# **Assorted Minolta Service Notes**

Minolta Service Bulletin's  
etc.

## SERVICE BULLETIN

SUBJECT: Light leakage -X-700

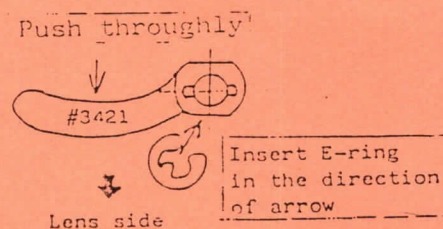
DETAILS: Light leakage as illustrated occurred.

On examination, it was found that the light leakage tended to occur as illustrated when taking the 25-30th frames (e.g. Frame counter shows "25-30") with a camera left under the sunshine for 20-30 minutes with ASA 400 Color film in it.

We found that the light leaked through S.L.S. shaft hole from S.L.S. window.

The light leakage tends to occur with ASA 400 Color film due to its spectral sensitivity as compared with B & W film.

We modify the direction of insertion of E-ring (9721-0150-13), as shown in the figure, so that the degree of light leakage will decrease.

### - Release magnet base plate interchangeability

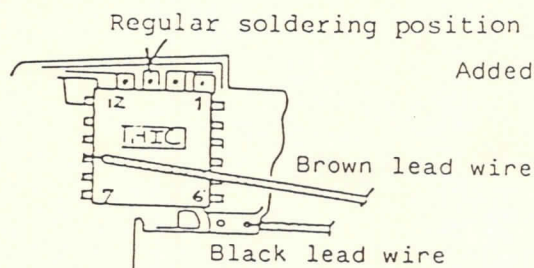
Release magnet base plate is available in the following 3 types:

2006-0580-04 and -05 : Used for 2006, 2007, 2009, and 2013

2019-0580-11 : Used for 2019

2019-0580-11 is interchangeable with body that 2006-0580-04 and -05 are attached

Added brown lead wire

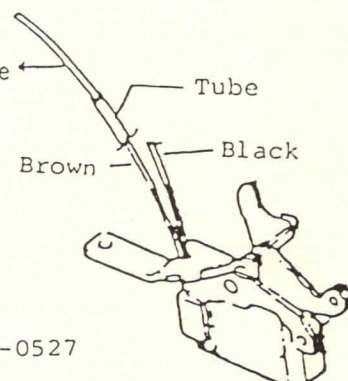
When used for XG-series, soldering 2019-0580-11 at the regular place is impossible because the brown lead wire is too short. So, handle this as follows:

Connect the brown lead wire to IC-4(HIC) pin ⑨ instead of the regular place as illustrated. Be sure to insulate the soldered part with tube.

SUBJECT : Frame counter stops at just before "1"

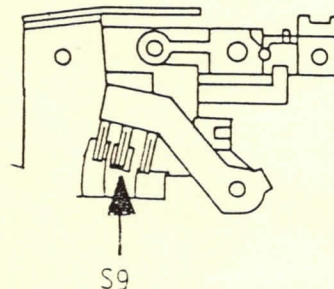
Contact failure of S9.

Modification of dimension of counter switch lever axis to have stable contact pressure ..... since December 1983 production.

Bend S9 slightly to strengthen contact pressure.
